TO: Board of Supervisors Agenda of: February 28, 2012

RE: Rezone Z10-0009/Planned Development PD10-0005/Tentative Parcel Map P10-0012/Creekside Plaza

**Creekside Plaza
El Dorado County, California
Conceptual Oak Mitigation Plan**

FIGURE 1

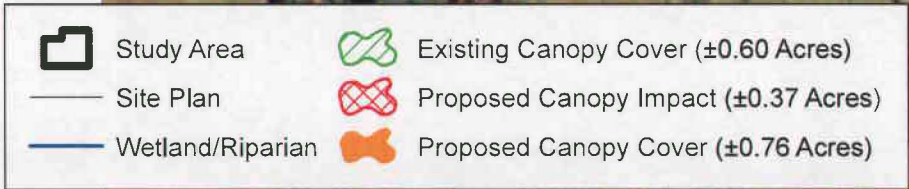
Figure 1. shows the proposed project, oak tree canopy to be removed, and proposed planting areas (i.e. oak replacement areas). Calculations to determine the area needed for oak mitigation is included in the following table:
